Appendix I

LICENSING REVIEW GROUP ISSUES

The Licensing Review Group (LRG) was formed in April 1980 to provide a vehicle for expediting the licensing process for General Electric (GE) boiling water reactors (BWR). The group was made up of six utilities, GE, and the consulting firm of KMC. Membership was at both the executive and technical level.

Plant unique positions were then developed. This appendix is for Columbia Generating Station, but uses common positions when applicable.

Figure I.8-1

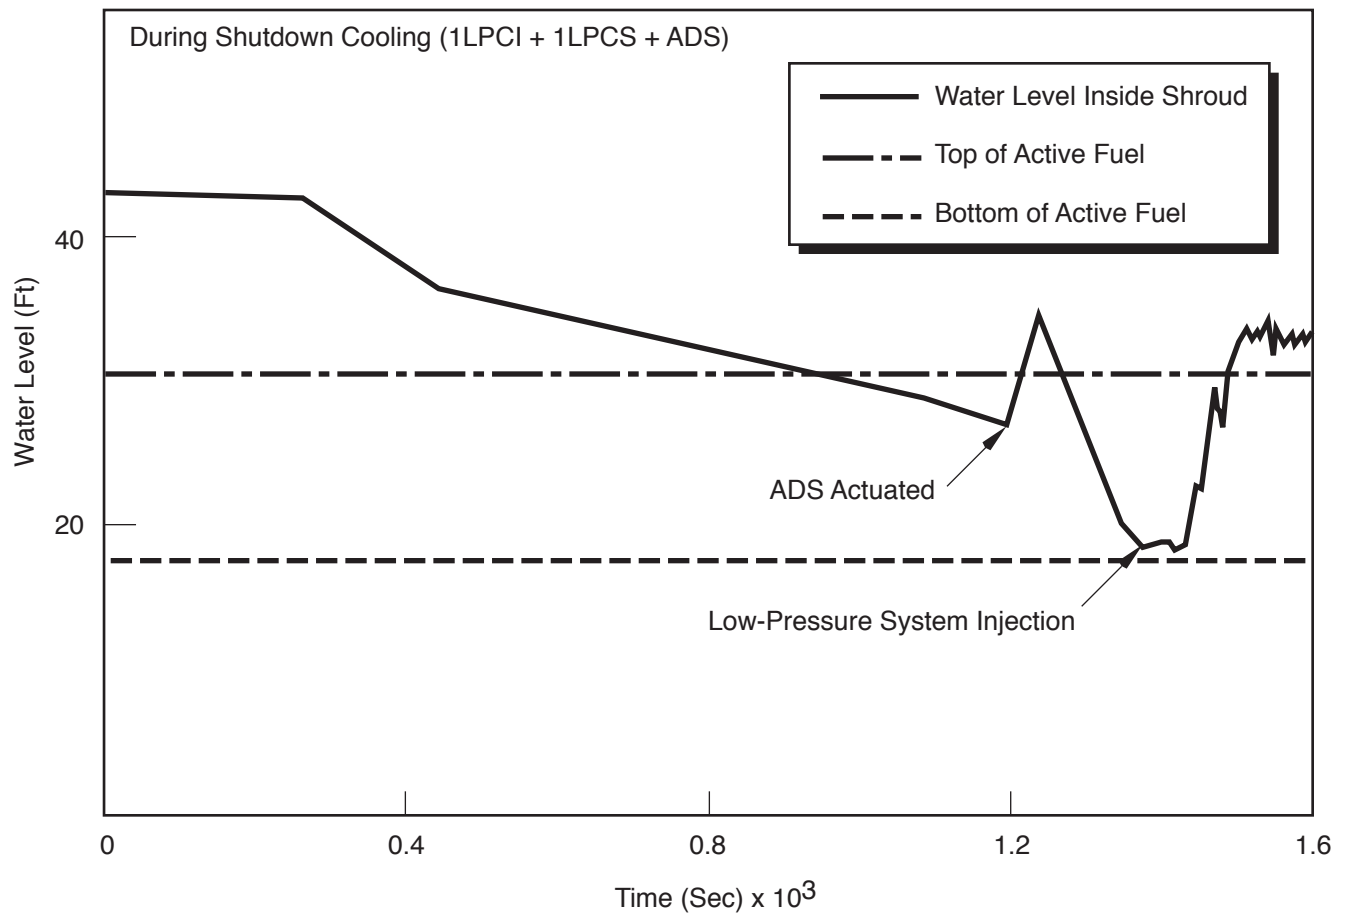
Provide the following information related to pipe breaks or leaks in high or moderate energy lines outside containment associated with the RHR system when the plant is in a shutdown cooling mode.

- a. Provide the discharge rate from pipe breaks for the systems outside containment used to maintain core cooling. This valve should be consistent with the requirements of SRP 3.6.1 and BTP APCSB 3-1.*
- b. Determine the time frame available for recovery based on these discharge rates and their effect on core cooling.*
- c. Describe the alarms available to alert the operator to the event, the recovery procedures to be utilized by the operator, and the time available for operator action.*

Results from this conservative analysis show that more than 20 minutes are available for the operator to depressurize the vessel. Once the system pressure is below the LPCI or LPCS shutoff head, the reactor water level is restored to normal limits very rapidly. The maximum clad temperature is much less than the arbitrary 2200°F limitation.
